Subject: LADWP BRRTP Crossing #40-2 to 40-3
(120th St W x Ave F-12, Antelope Acres)
Barren Ridge S.S. to Haskell S.S. T.L. R/W
Antelope-Magunden #1 & #2 220kV T/L
APN 3266-004-051; 052; 056 and 3265-002-034
SCE File No. CON203051280

Southern California Edison Company (SCE), has reviewed and approved your request for Department of Water and Power, City of Los Angeles (LADWP) crossing the SCE Transmission Line shown on the attached plans entitled "Crossing at Southern California Edison Span 40-2 to 40-3, Drawing Number L83-SCE-40-2, sheet 1 of 1, dated June 25, 2015, date stamped approved by RP on August 21, 2015.

REVISION			CROSSING AT SOUTHERN CALIFORNIA EDISON SPAN 40-2 TO 40-3 BARREN RIDGE S.S. TO HASKELL S.S. T.L. R / W			
NO	DRN	CKD				
ENGINEERING APPROVAL			DRN	CKD	Steve Boyles	
FINAL APPROVAL RELEASE SIGNATURE			EP	DN	Nick Demos 6/25/15	
DESCRIPTION			POWER SYSTEM DEPARTMENT OF WATER AND POWER CITY OF LOS ANGELES			
			DRAWING NUMBER L83-SCE-40.2

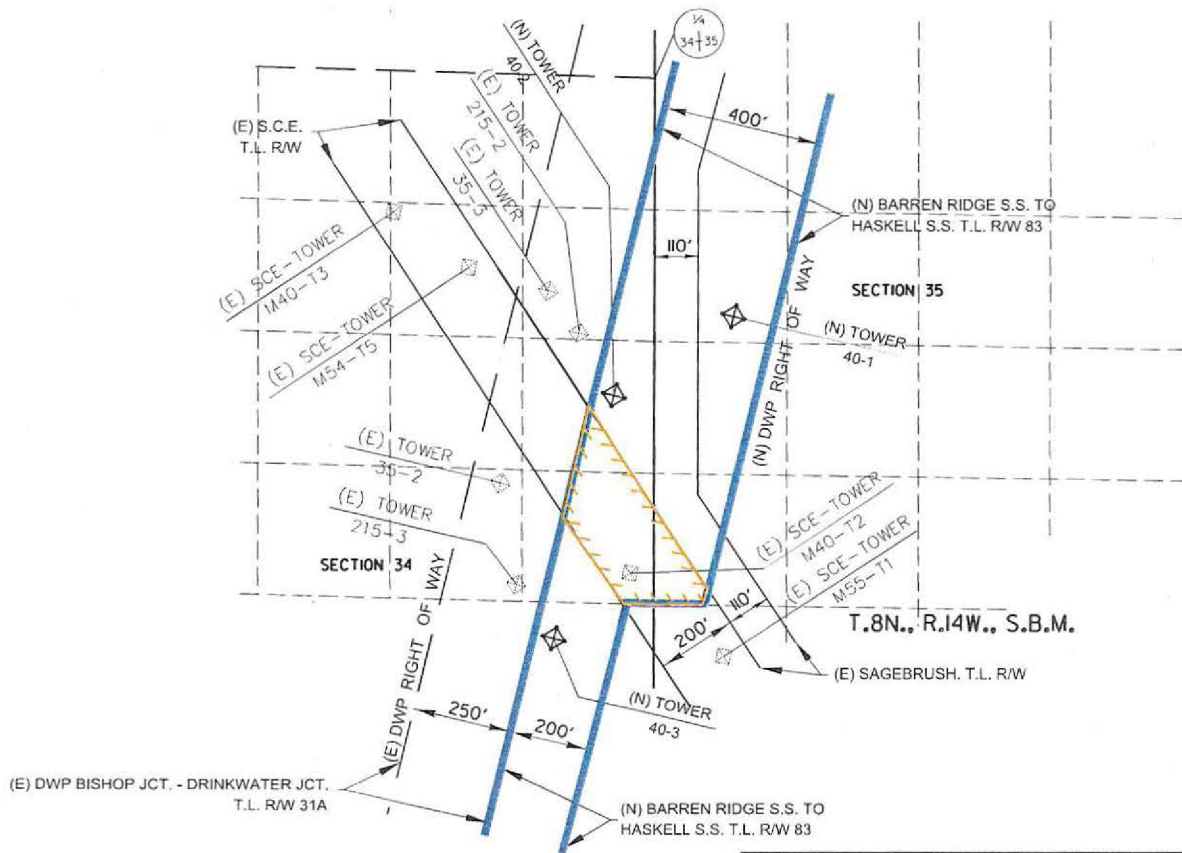
1. Adequate access to all structures must be provided and at no time is there to be any interference with the free movement of SCE's equipment and materials. (See Addendum 1 Table 1 - Standard Clearances)

14. Underground facilities installed on the right of way shall have a minimum cover of Three feet (up to Seven feet depending on facility type and location). The ground cover shall be a minimum of Five feet where the underground facility crosses access roads that are earthen. All underground facilities shall be capable of withstanding a gross load of 40 tons on a three-axle truck. All pipelines and underground facilities must conform to ASTM standards as well as any State and Local agency requirements and specifications.

15. Horizontal underground clearances from SCE structures or facilities must be a minimum of Ten feet. Vertical underground facilities clearances from SCE structures or facilities must be a minimum of Three feet, and possibly up to seven feet (depending on type of crossing and voltage). If underground crossings to SCE facilities are made by water lines, LADWP shall be responsible for potential underground installations that result in induced voltages (i.e. Cathodic Protection)

33. All tower and steel pole foundation projections are to be maintained between one and two feet above finished grade.
 34. Under no circumstances shall SCE's right of way be used or dedicated by LADWP for any environmental mitigation efforts. Any water quality measures, such as bio-retention, bio-swales, or other water quality features requiring maintenance shall not be allowed on the right of way.
